REVISION #1 09/16/2024
REVISED SHEETS: EC1-EC3, U1-U3, U6, U7
REVISION #2 02/28/2025
REVISED SHEETS: EC1, PD4, P4, U4, S1, S2, S3, S6 - new sheet, X8, X9
REVISION #3 04/25/2025
REVISED SHEETS: PD3, P3, X5, X6
REVISION #4 04/28/2025
EVISED SHEETS: G11, G12, G14 - new sheet, PD3, P3, P4, P6, U3, U6, X4, X5

PLAN OF PROPOSED IMPROVEMENT

KNUTSON DRIVE AND GREEN AVENUE ASSESSMENT DISTRICT - 2024

CITY PROJECT NO. 13812
CONTRACT NO. 8635

13812
P-3

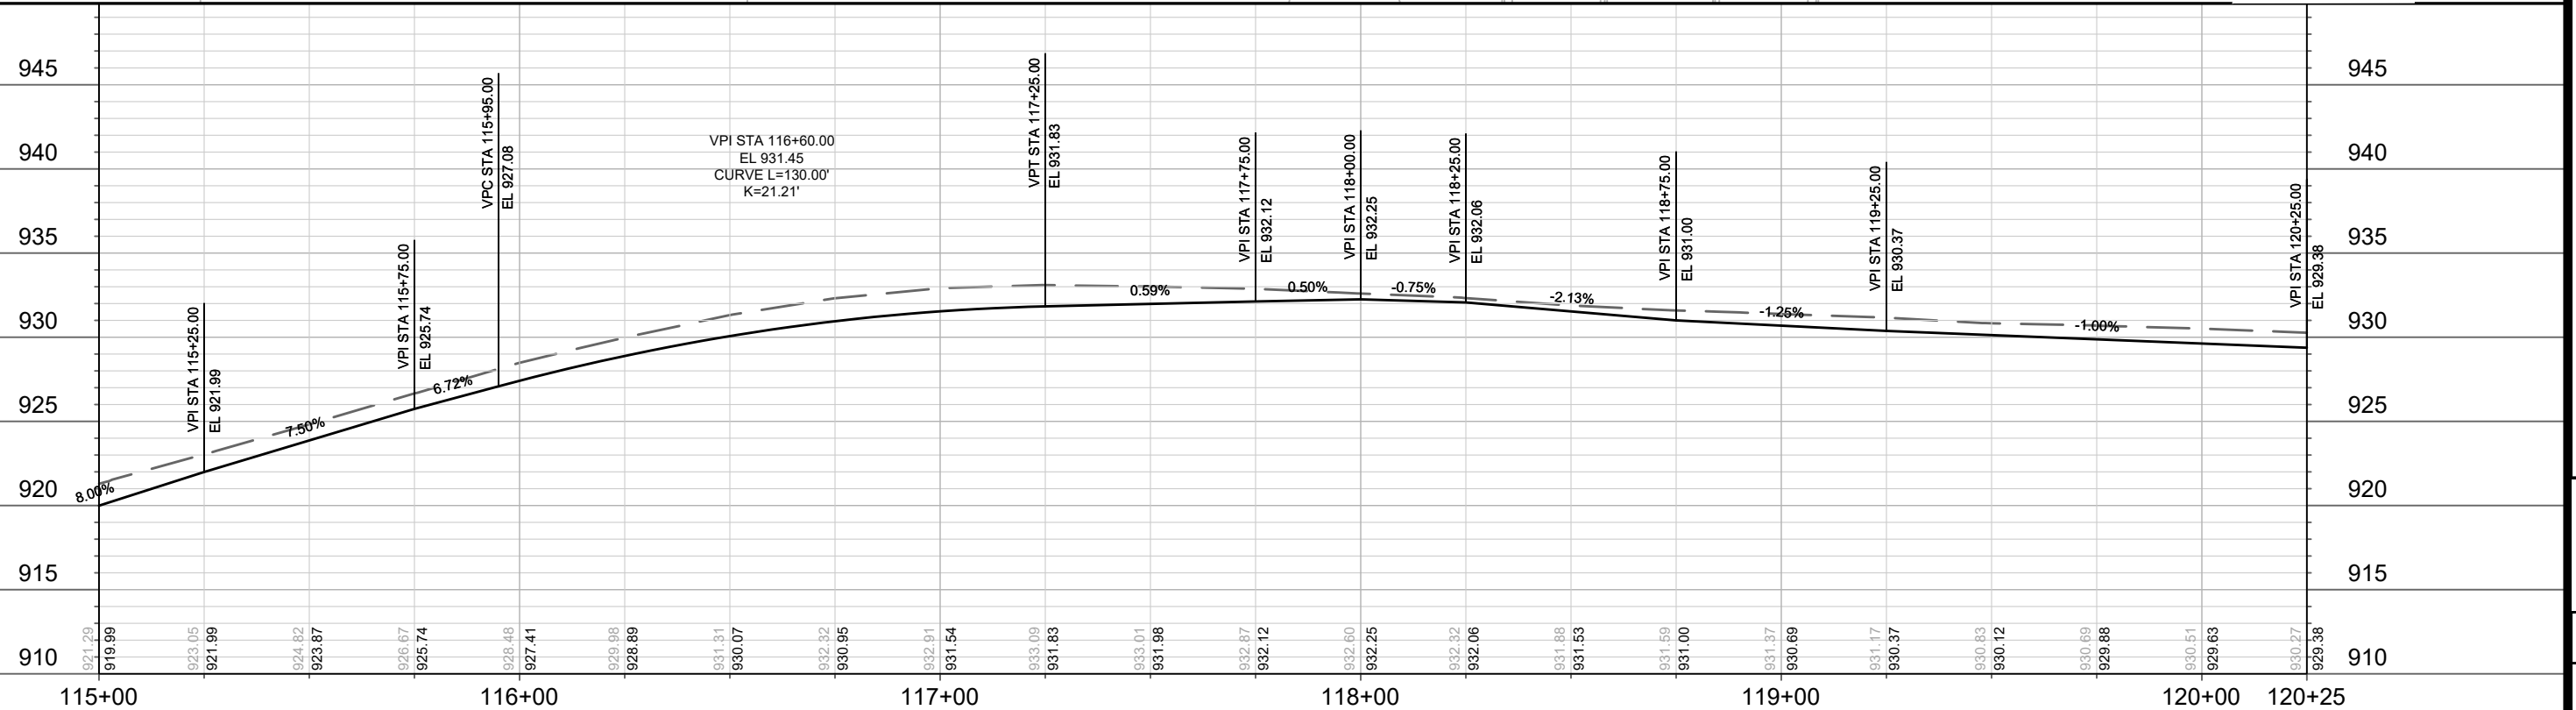
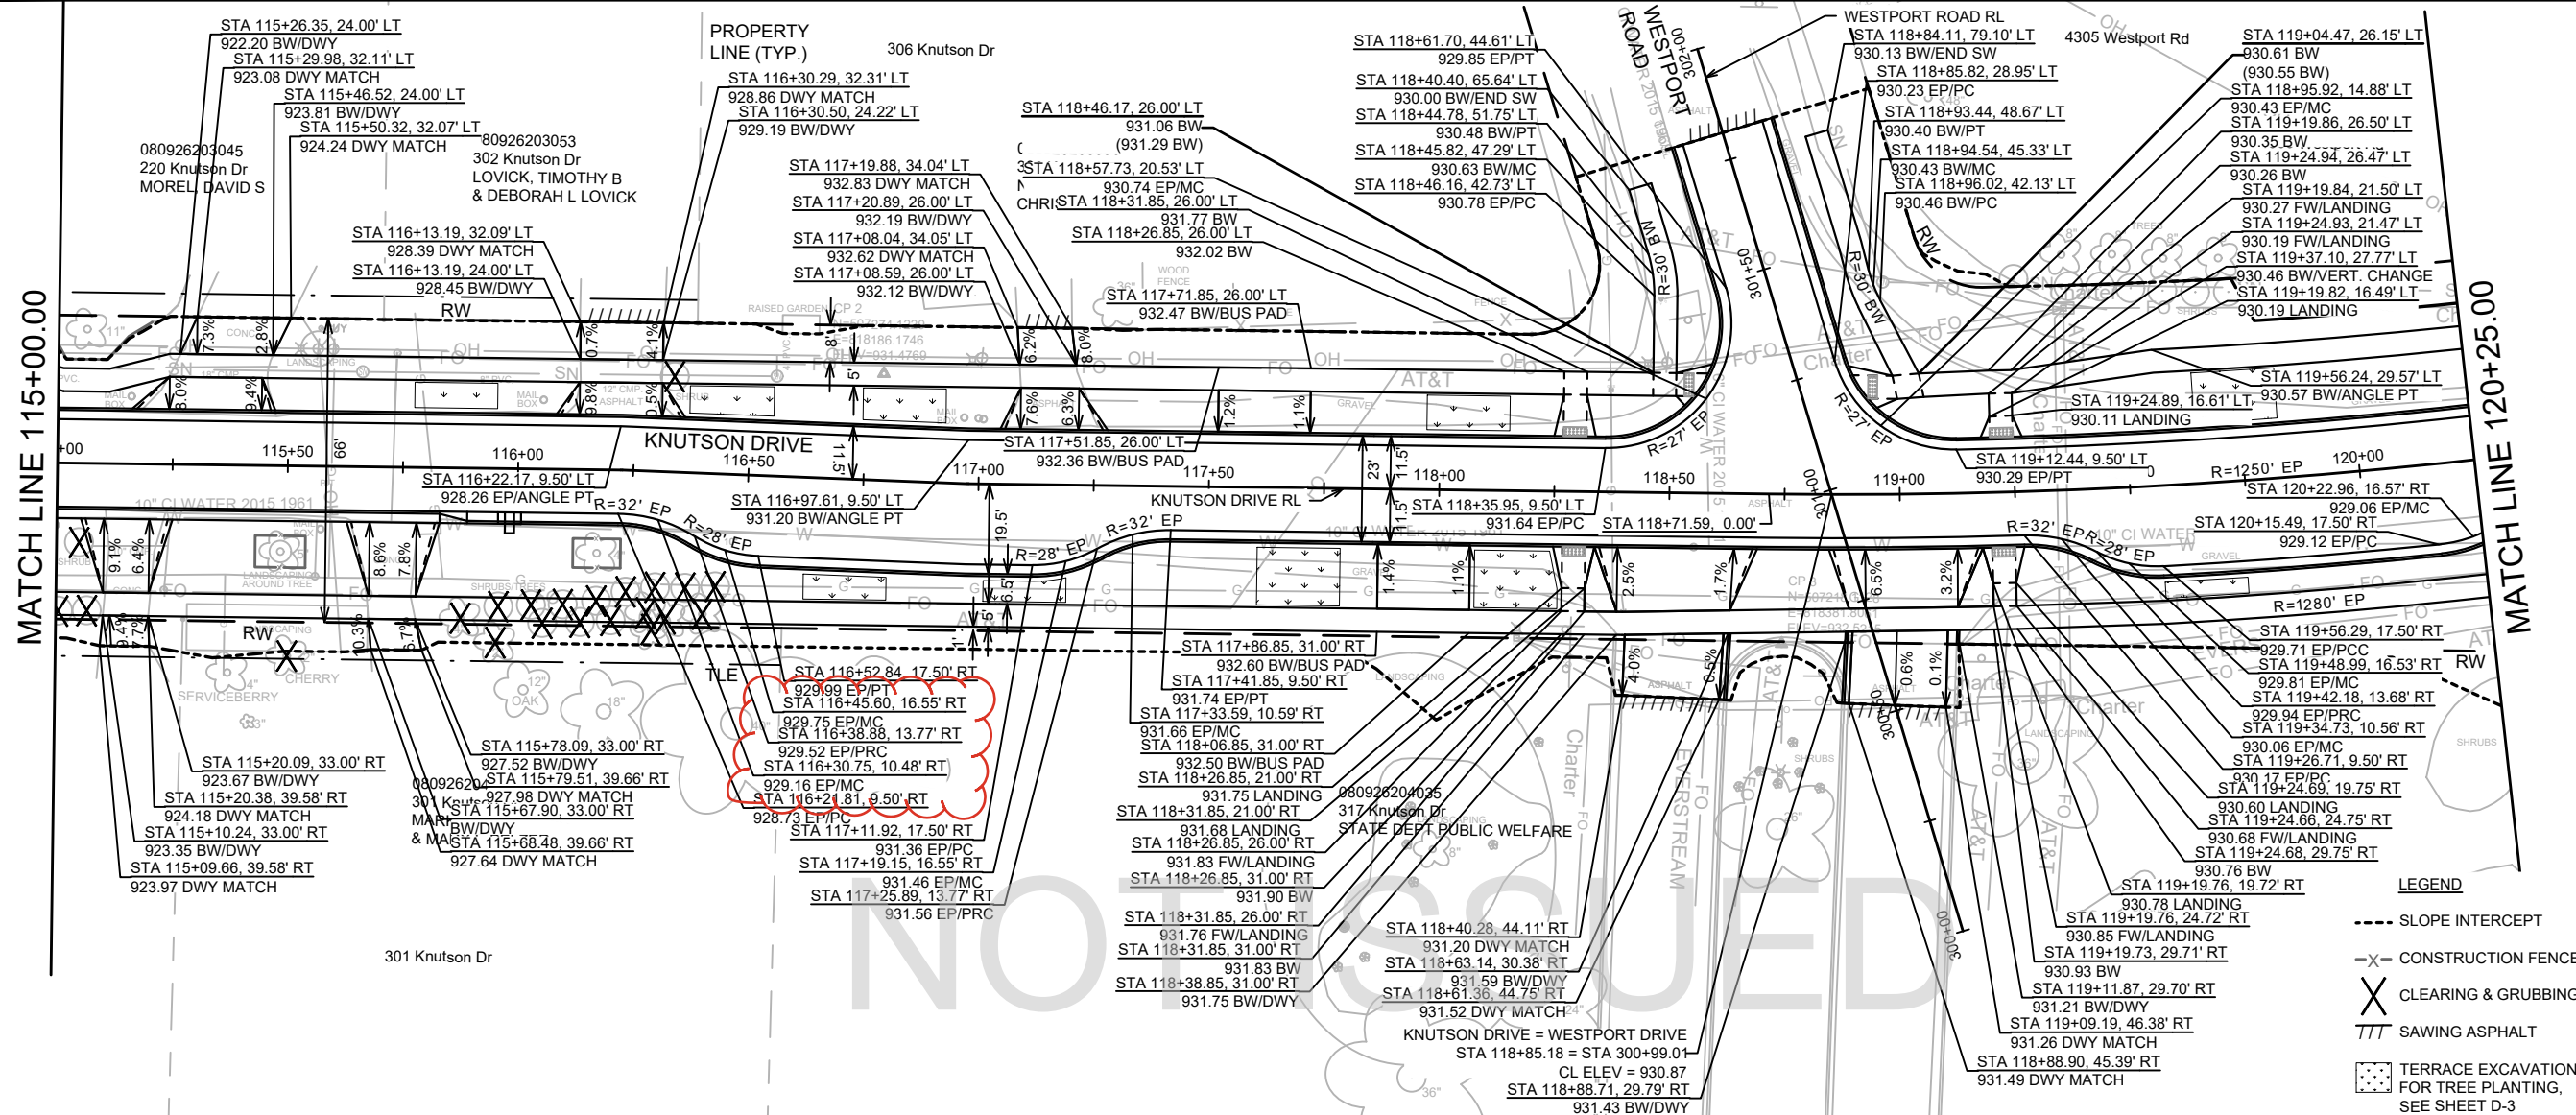
REV4	REVISE PROFILE CROSS SLOPE SW DWY	4/28/25	AJZ	DATE	BY
REV3	REVISE CROSS SLOPE	4/25/25	AJZ	REVISION	DATE
Designed By: AJZ					Scale: 1" = 40'
13812					P-3

3812
P-4

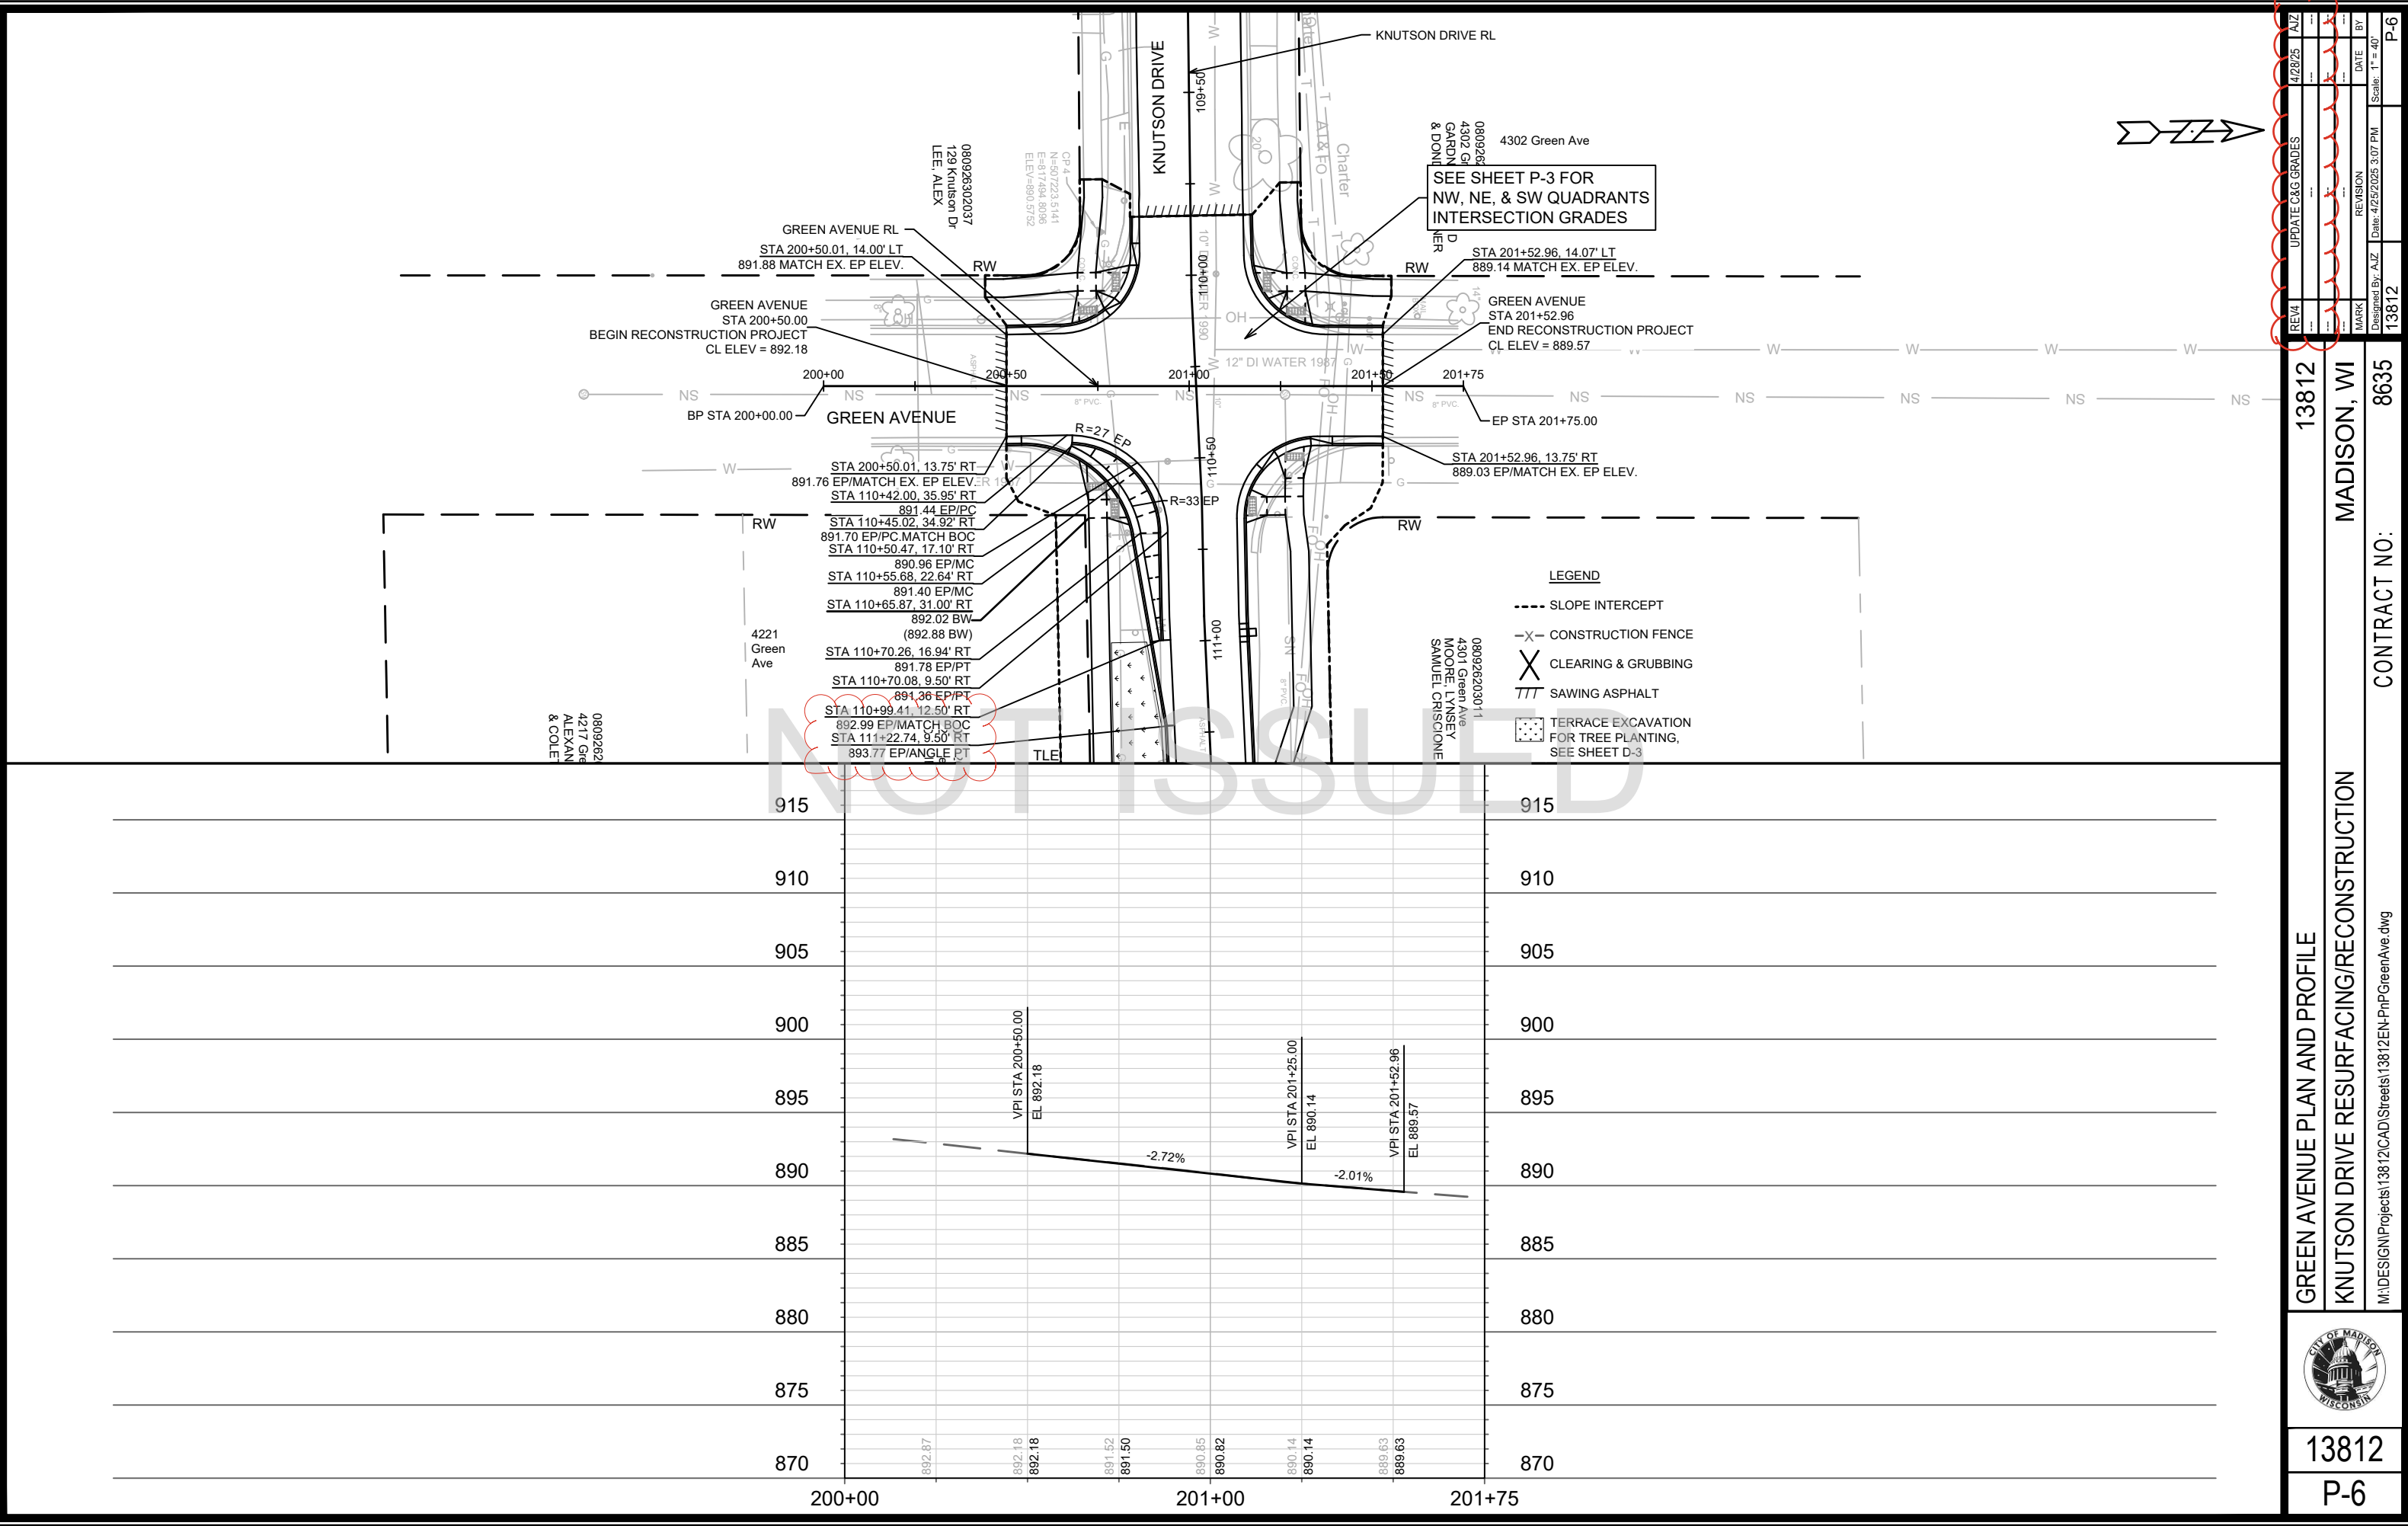
REV1	REVISE C&G GRADES	DATE: 4/25/25	AJZ
REV2	UPDATE BUS PADS	DATE: 2/28/25	AJZ
MAJOR	REVISION	DATE: 4/1	AJZ
Designed By: AJZ		Date: 4/28/2025 3:07 PM	Scale: 1" = 40'
13812			P-4

GENERAL PLAN

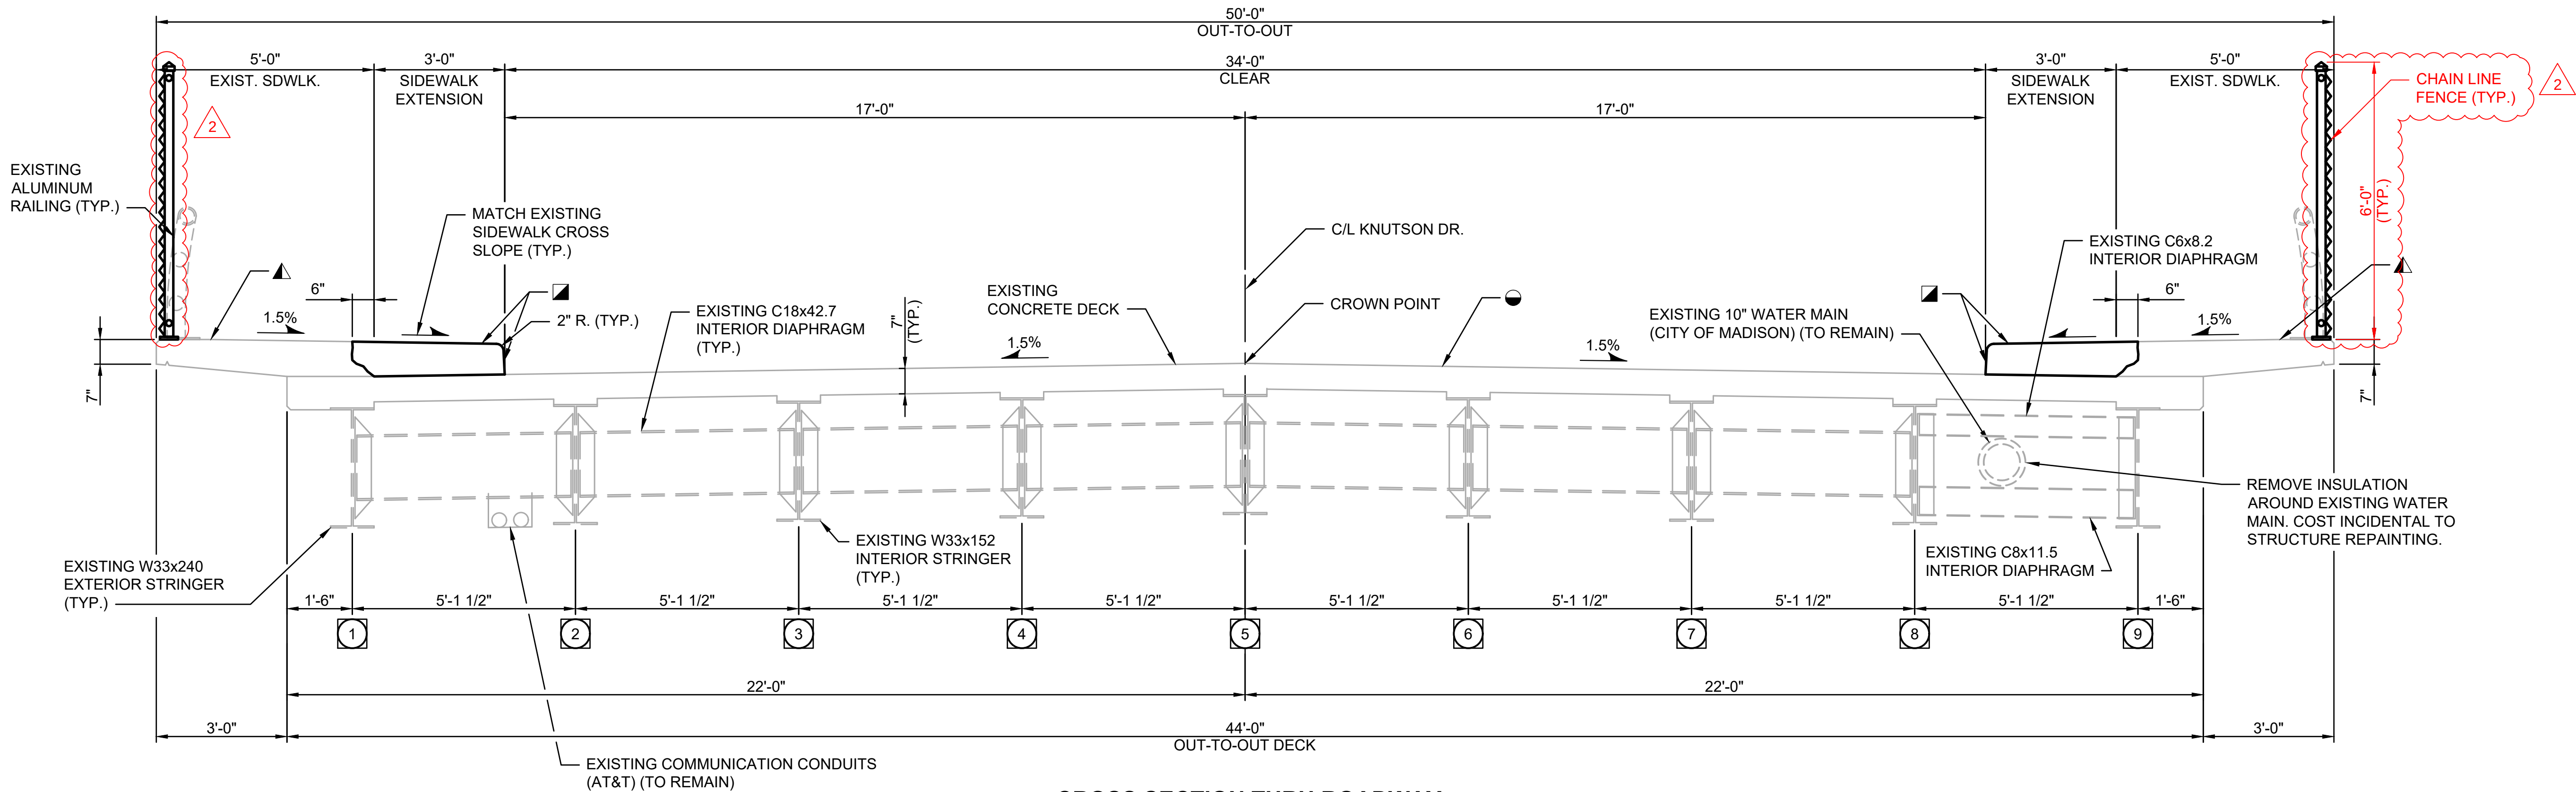
DATE:	2/7/2025								
NO.	2								
REVISIONS	ADD 6'-0" FENCE
